Accessibility Survey

City of Downey Phlox Street - Paramount Boulevard to Downey Avenue

Date of Inspection
5/20/2017

Disability Access Consultants

Change in Level West of Downey Avenue @ 33.940292544551, -118.139309585094

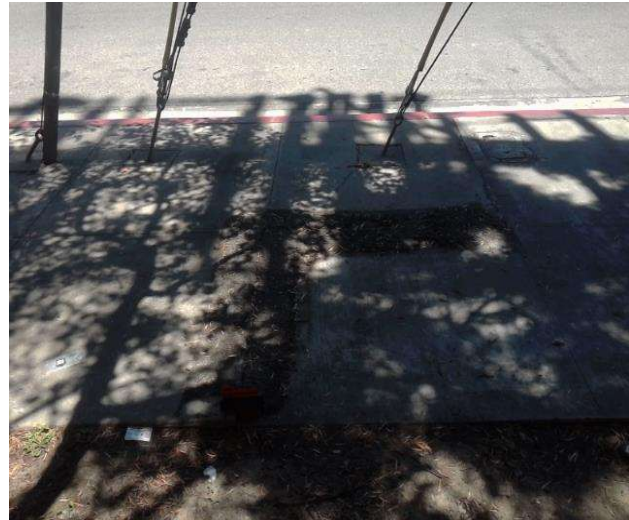
There is a change in elevation greater than recommended value.

On-Site Finding 1.50 inches

Ensure that the change in elevation is within the recommended value.

Recommendation Up to 0.25 inches

Change in Level West of Downey Avenue @ 33.939130974999, -118.136986792088

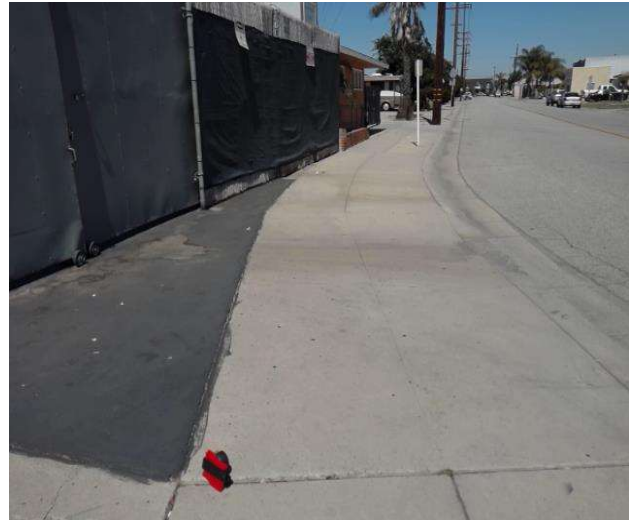
There is a change in elevation greater than recommended value.

On-Site Finding 0.75 inches

Ensure that the change in elevation is within the recommended value.

Recommendation Up to 0.25 inches

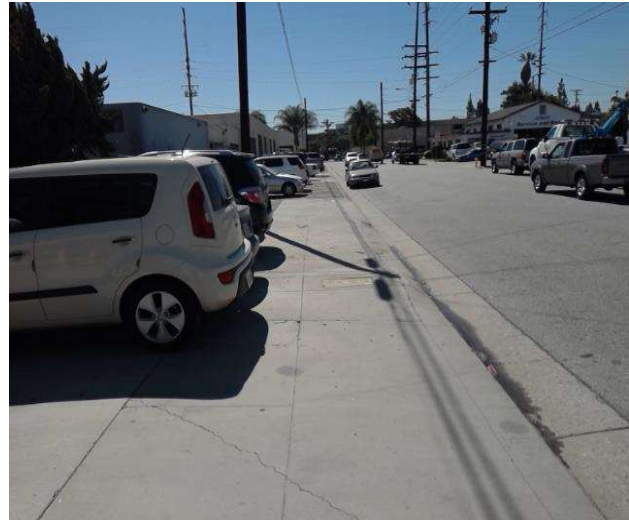
There are no detectable warnings where the pedestrian route crosses vehicular traffic.

On-Site Finding Not Found

Provide detectable warnings.
